## PLN16/116- 341-347 George Street, Fitzroy

**Attachment 5 - PLN16/1116 - 341 - 347 George Street, Fitzroy - Heritage advice (decision plans).**

**Attachment 6 - PLN16/1116 - 341 - 347 George Street, Fitzroy - Urban Design comments (decision plans).**

Referral Response by Yarra City Council

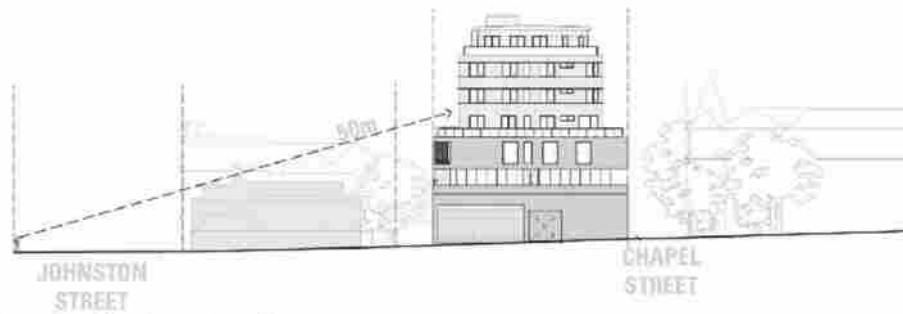
The DDO10 contains a discretionary maximum height of 4 to 6 storeys, with built form to be setback to meet various discretionary view line and amenity tests. The proposal at 7 storeys exceeds this preferred height by 1 storey. Therefore, relevant to the proposal, upper forms should avoid increased overshadowing of street and public space between 10am and 2pm at the equinox and minimise visual intrusion of upper levels when view from footpaths and public spaces.

The existing building, as demonstrated by the shadow diagrams, already significantly overshadows Chapel Street, between 10am and 2pm at the equinox. However, there appears to be an error in relation to the extent of existing shadows at 1pm and 2pm. Irrespectively, the existing building (which is largely proposed to be retained) already overshadows Chapel Street.

Site Planning

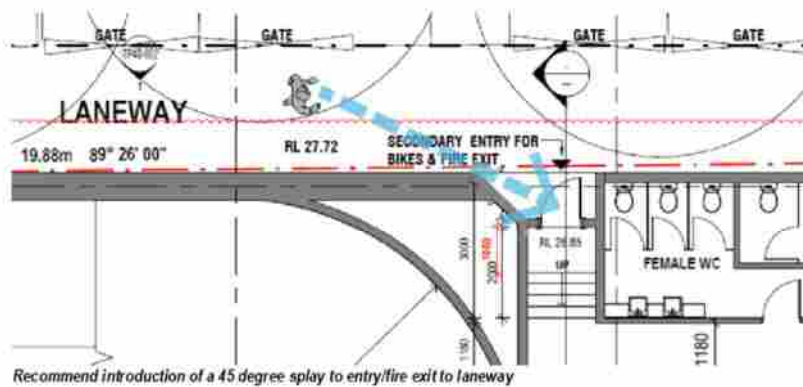
- We are supportive of the provision and extent of active frontage provided at ground level with frontage to George Street and wrapping the corner into Chapel Street. These tenancies are highly glazed and will provide appropriate engagement and activation of the street at ground level. The main building entrance is appropriately integrated into the heritage fabric and provides an appropriate 'sense of address' to George Street.

- The core is well located and responds to the site's stepped northern boundary by allowing an efficient basement layout, a large and flexible retail tenancy at ground and is concealed within the form at all upper levels.

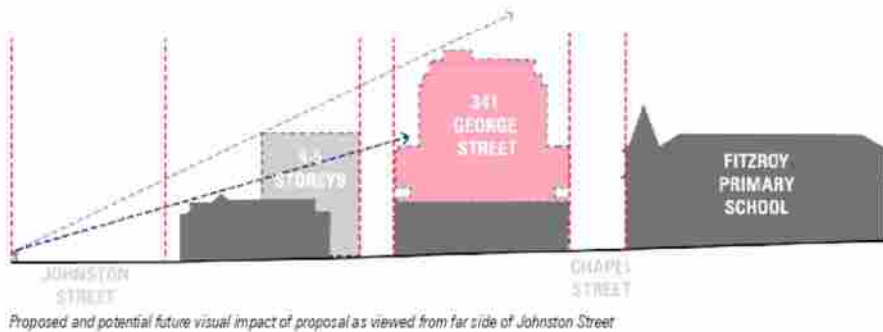
While, the subject site is situated behind a row of attached single storey terrace housing with a pitched roof and the 2 storey Rochester Castle Hotel. These relatively low heritage forms allow the upper 4 levels of the proposal to be clearly visible from the northern (far) side of Johnston Street. We acknowledge that these individual dwellings are under a single ownership, which increases their potential to accommodate development in the future. Given, the need to appropriately respect the single storey heritage terraces, we envisage that a modest 4-5 storey form could be contemplated to the rear of these consolidated properties. If such a form were to exist (in the future) it would considerably conceal (or completely hide) the proposal from views from Johnston Street.

In the interim, the revised proposal has suitably enhanced the architectural expression of its rising form to create an articulated façade presentation which introduces stronger horizontal division to suitably 'break-up' the previously 'sheer' appearance. We consider the revised architectural expression to be acceptable.

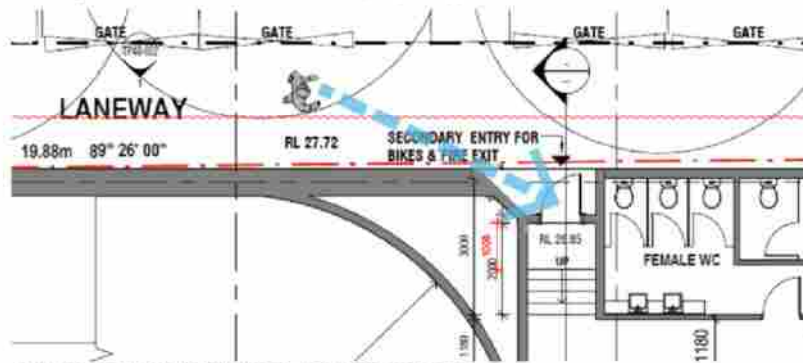
- Bicycle storage is provided at ground level, in a centrally located and convenient position. It also benefits from three points of access, either via the vehicle entry, through the front door or via a secondary entry to the laneway.
- In order to improve the safety of the laneway, we would recommend that a 45 degree splay be incorporated within the western wall of the secondary pedestrian entry/fire exit to enable sightlines into the recessed doorway (upon approach from Rochester Street).
